County of Loudoun
Department of Planning
MEMORANDUM

SUBJECT: SPEX 2006-0042 & CMPT 2007-0002, Dulles South Water Tanks

**SUBJECT: SPEX 2006-0042 & CMPT 2007-0002, Dulles South Water Tanks –
Second Referral**

SUBJECT: SPEX 2006-0042 / CMPT 2007-0002
Dulles South Water Tanks

VICINITY MAP

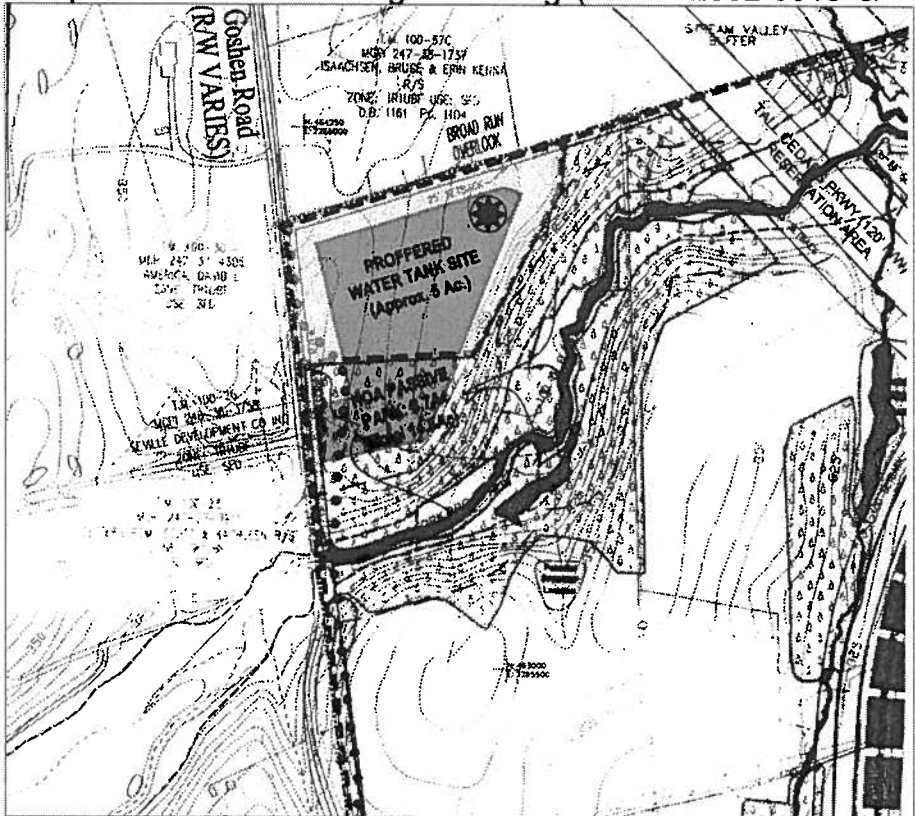
The proposed 5 acre site is located at the western edge of the Stone Ridge development, adjacent to Goshen Road. Development surrounding the site consists of:

- North - Marrwood at Stone Ridge (SBPL 2005-0007): 115 single-family detached units is located north of the site and a single-family detached home on a large lot;
- South and East - South Fork of Broad Run and its associated floodplain and 94 single-family detached units associated with the Stone Ridge community are located on the other side of the floodplain; and
- West - Westport (ZMAP 2005-0030 & SBRD 2006-0009) an active application for a residential community and a single-family detached home on a large lot (See Vicinity Map Above).

A 5 acre site was proffered as part of the Stone Ridge rezoning (ZMAP 2002-0013 & ZCPA 2002-0004) for an LCSA water storage/pumping facility. However, staff notes that the site shown on the proposed SPEX plat differs from the area shown on the approved Stone Ridge Concept Development Plan (CDP). The map to the right outlines the proffered site in yellow and the subject site in blue. The proposed site is located in a portion of the area proffered as part of the Stone Ridge rezoning; however, it also falls outside of the proffered site, in an area delineated as HOA Passive Park and tree conservation area.

Staff requests information pertaining to the difference in the site configuration.

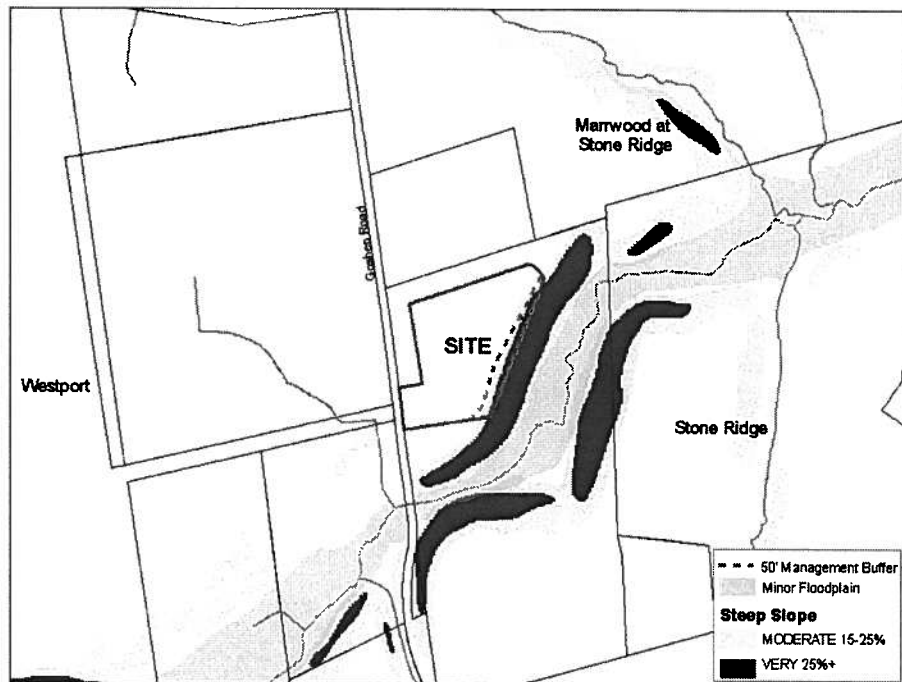
are met and maintained (*Revised General Plan, Policy 5, p. 5-6*). The 50-foot management buffer has been delineated on the submitted plat; however, it has not taken into account the adjacent steep slopes (slopes 25% of greater) as called for in Plan policies (See Map).

Staff recommends delineating all the elements of the river and stream corridor resource on the submitted plat and locating development outside of this area.

Moderately steep slopes have been delineated on the submitted plat; however, these locations differ from County GIS records (See Map Above). In addition, steep slopes greater than 25 percent have not been delineated on the submitted plat.

Staff recommends delineating steep and moderately steep slopes on the submitted plat and locating development outside of these areas.
